Cowm Top, Castleton, Rochdale

Application Reference 22/01190/FUL.

Response to LLFA Comments dated 6th November 2024

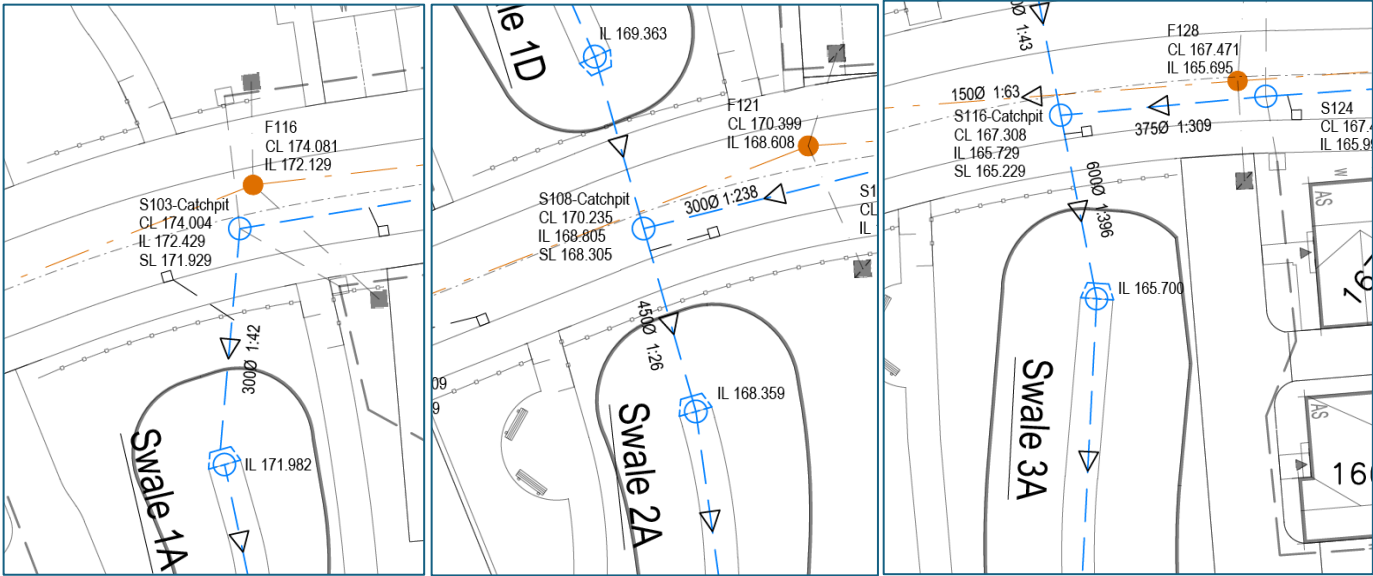
6	We would advise that inlets to the central swales incorporate sedimentation controls similar to the basins.	Noted. We have added catchpits at the manhole before the central swale inlets. Manholes S103, S108, S116 are now catchpit manholes. See the screenshot presented below. We do not need a forebay in each swale as the swales are already partitioned with the weir walls, which will act as the forebay. Adding a separate additional forebay will only serve to reduce the swale volume capacity. The following drawings have been revised to add catchpits to the inlet of the Swales. H8544-BAH- XX-XX-DR-CE-300001 Rev P06 – Preliminary Engineering Layout Sheet 1 H8544-BAH- XX-XX-DR-CE-300002 Rev P07 – Preliminary Engineering Layout Sheet 2 H8544-BAH- XX-XX-DR-CE-300003 Rev P05 – Preliminary Surface Water Drainage Strategy (attached below) Drainage Strategy Report Rev G Nov 24 
7	If planning approval is granted then it should include references and compliance with the reviewed documents.	Agreed.
